SUBJECT: Comment Response Letter – Meridian Road (CDR-19-004)

Please see the following responses in ***bold and italics*** for the 2nd review of Bent Grass Residential Filing No. 2.

Figure 2-27. Required Storage Lengths for Signal-Controlled Intersections

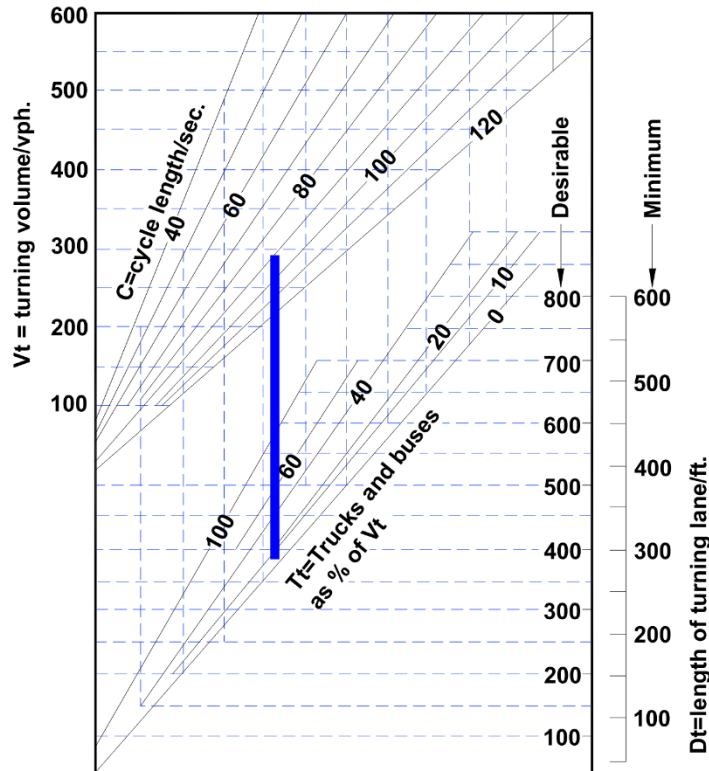
See comment letter regarding SB right turn at BGM Dr. and ECM Figure 2-27 (provide).

See comment letter regarding SB right turn at BGM Dr. and ECM Figure 2-27 (provide).

Author: Kirstin Subject: Sticky Note Date: 7/23/2020 19:31:05
Storage length is not needed for right-turn deceleration lanes. ECM Figure 2-27 is intended for LEFT TURN LANES (as per attached documentation). The current right-turn lane meets criteria.

Figure 4

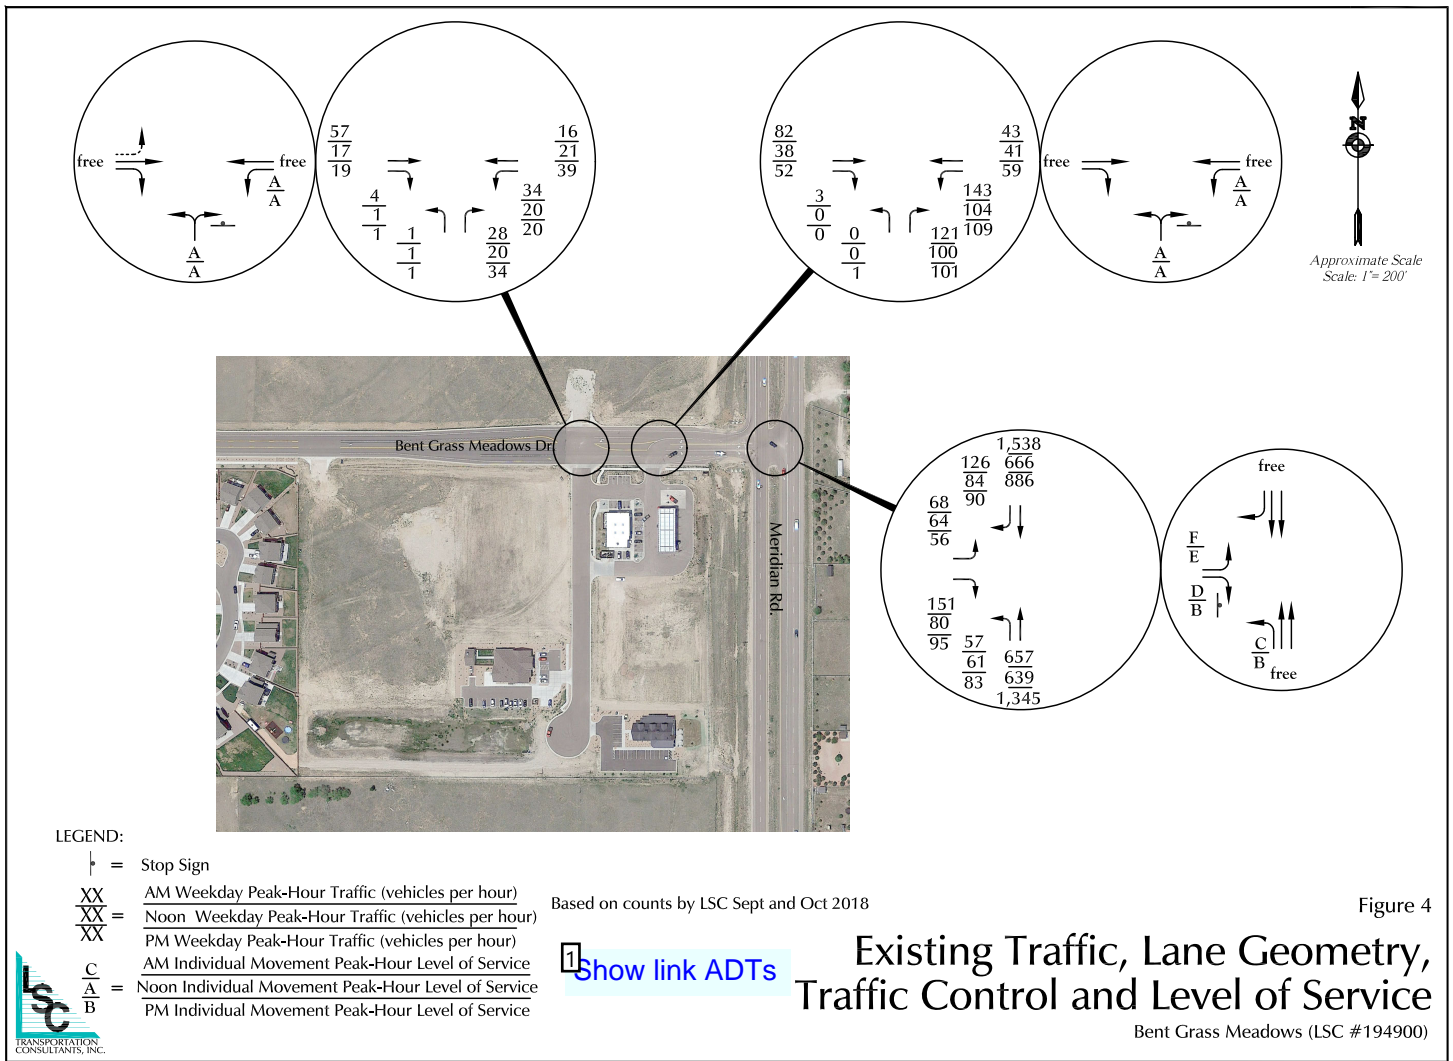
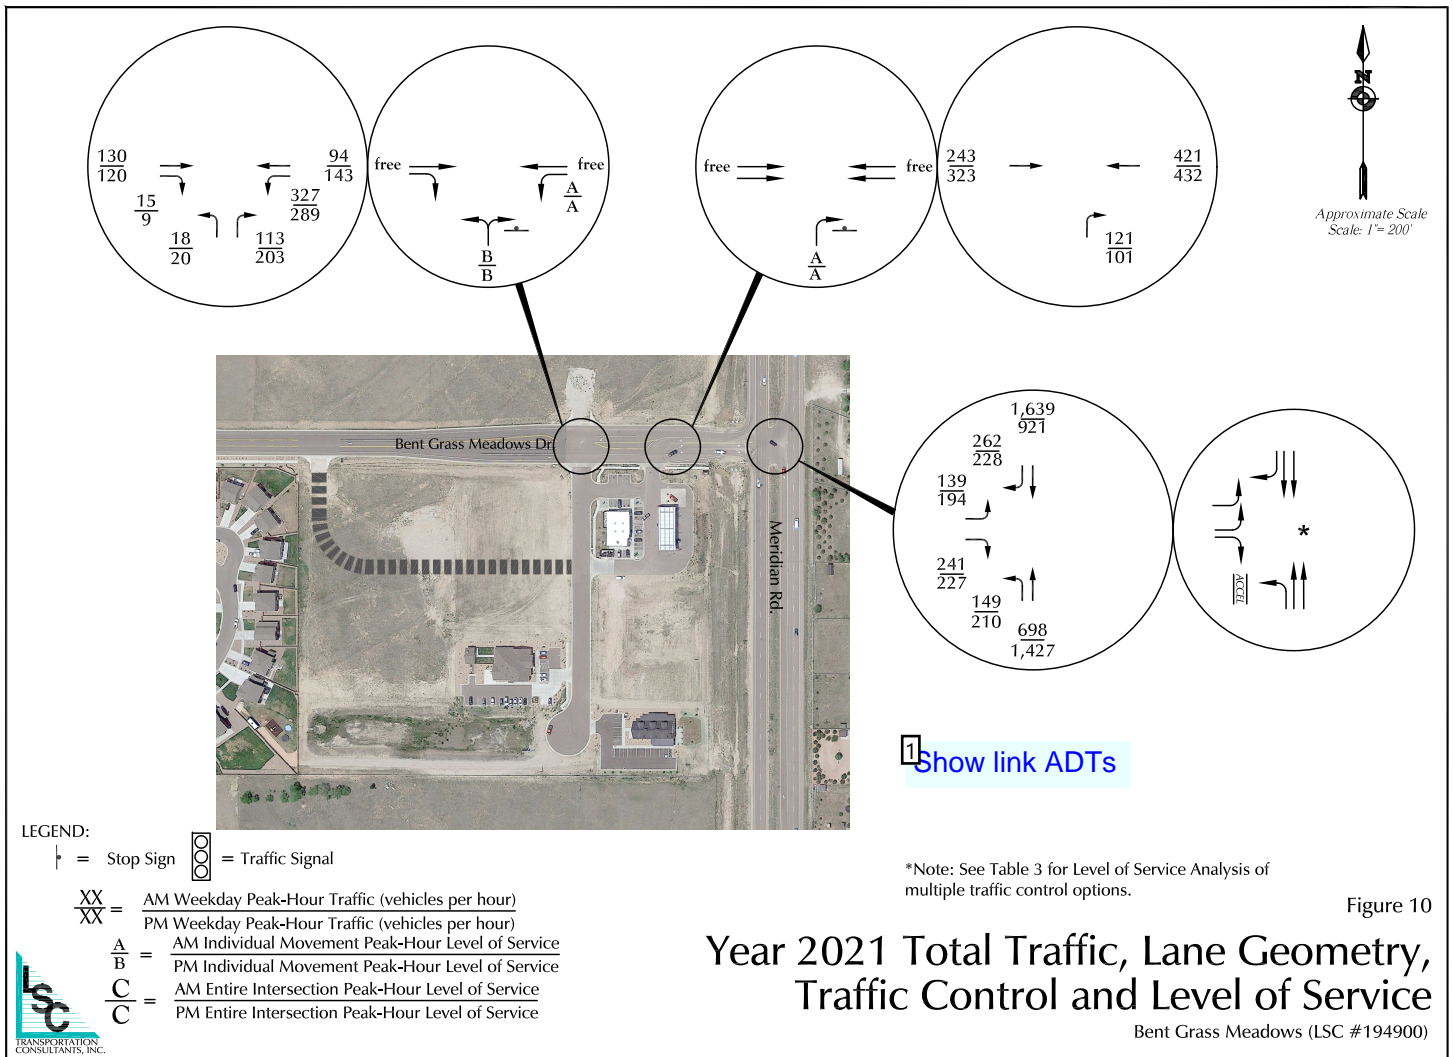
[Show link ADTs](#)

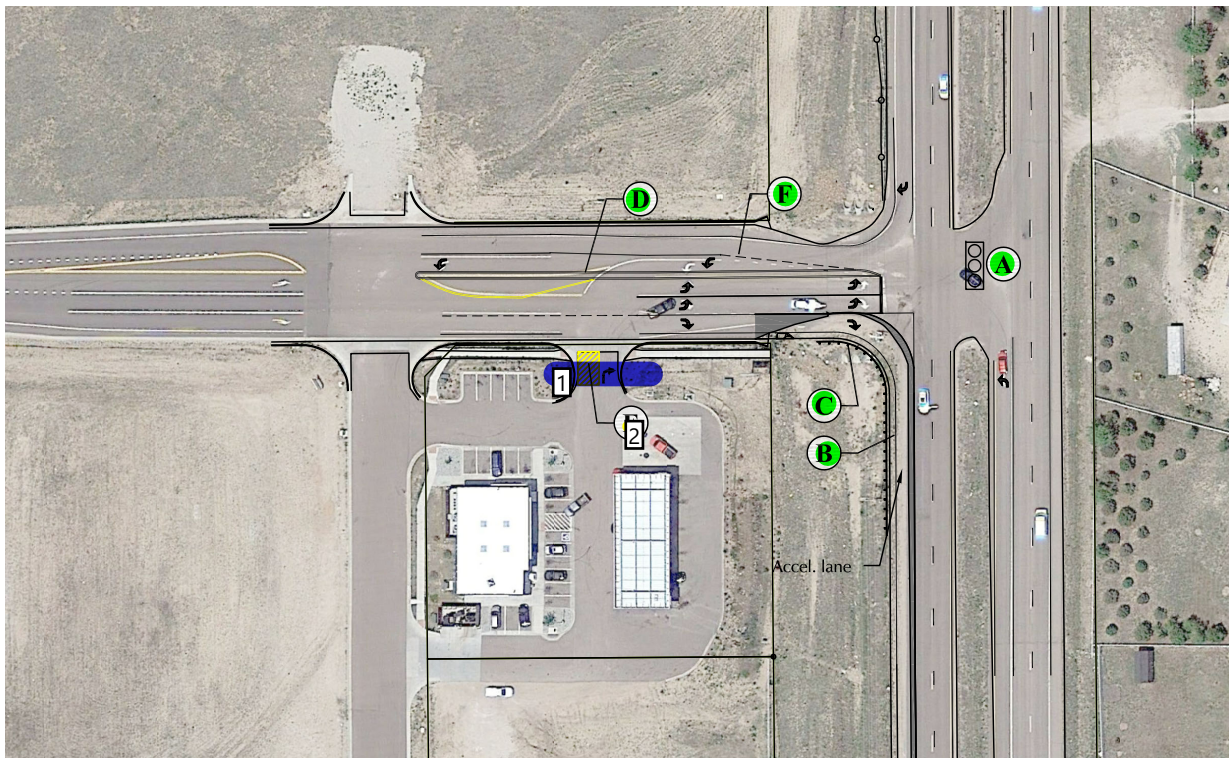
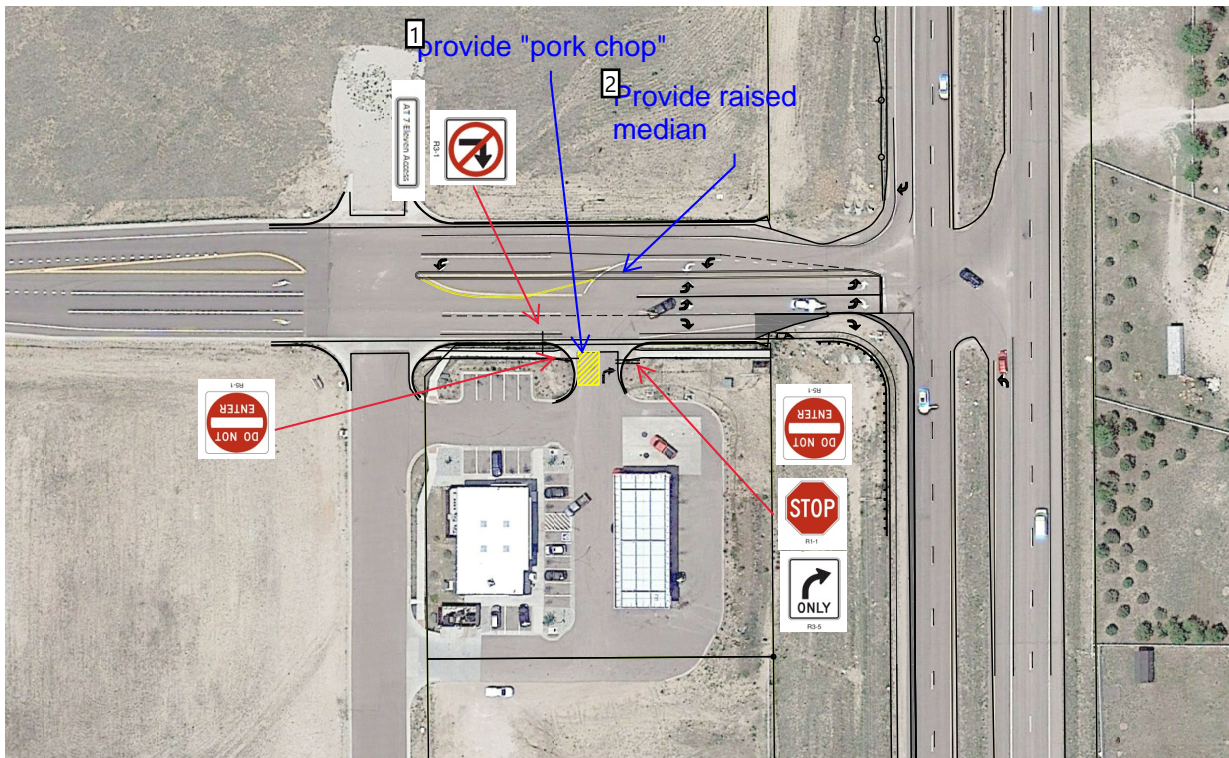
[Show link ADTs](#)

C6.1

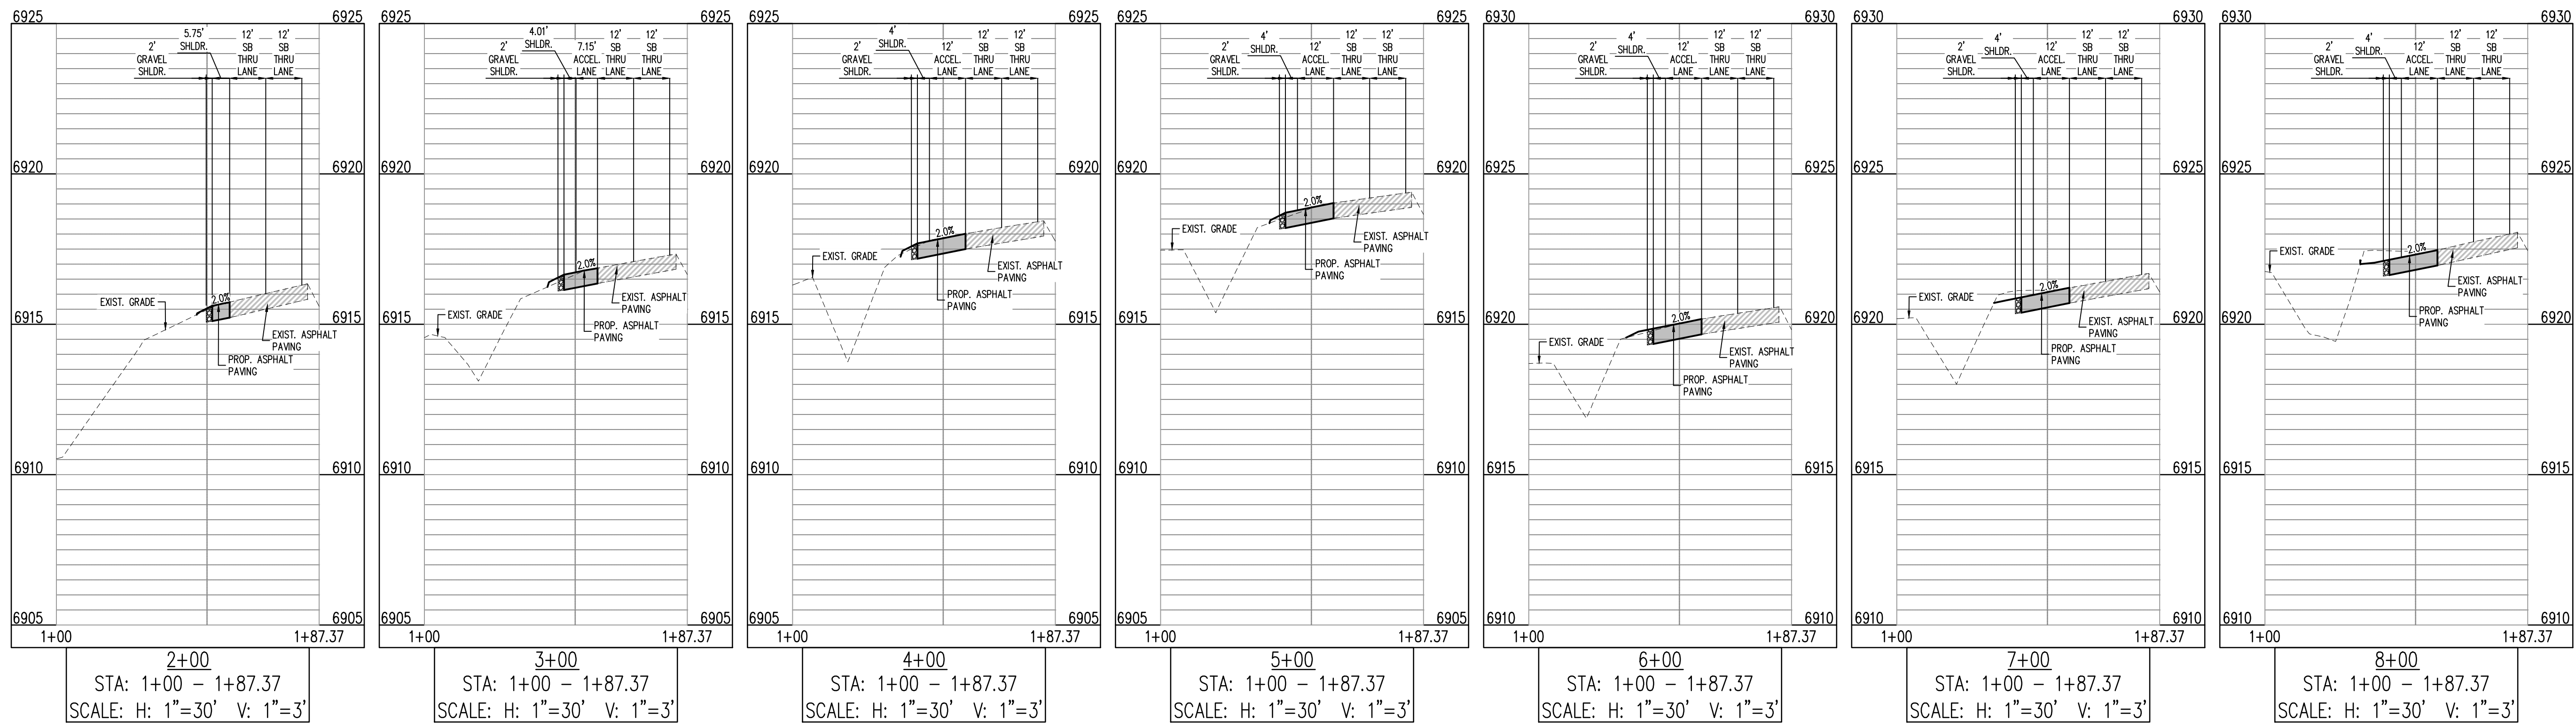
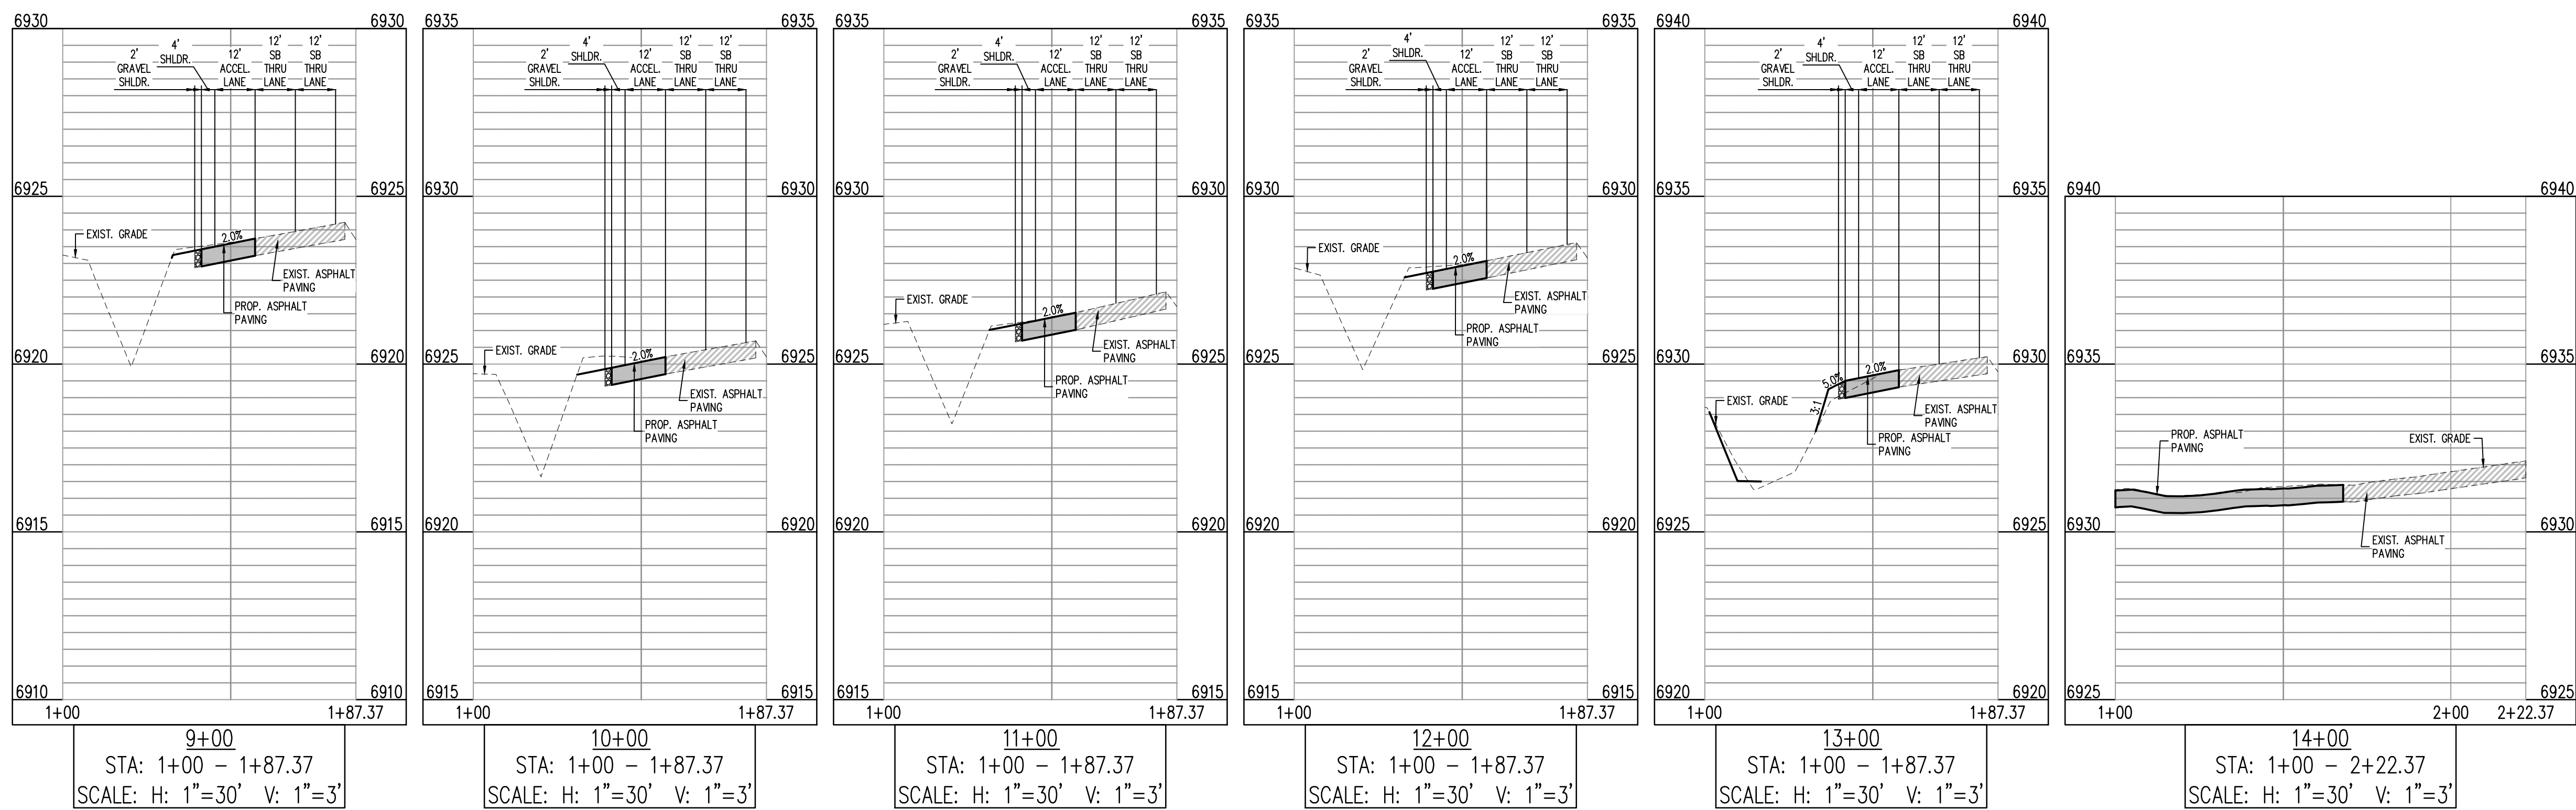
Label all ditch foreslopes and backslopes.

All foreslopes and
backslopes labeled.
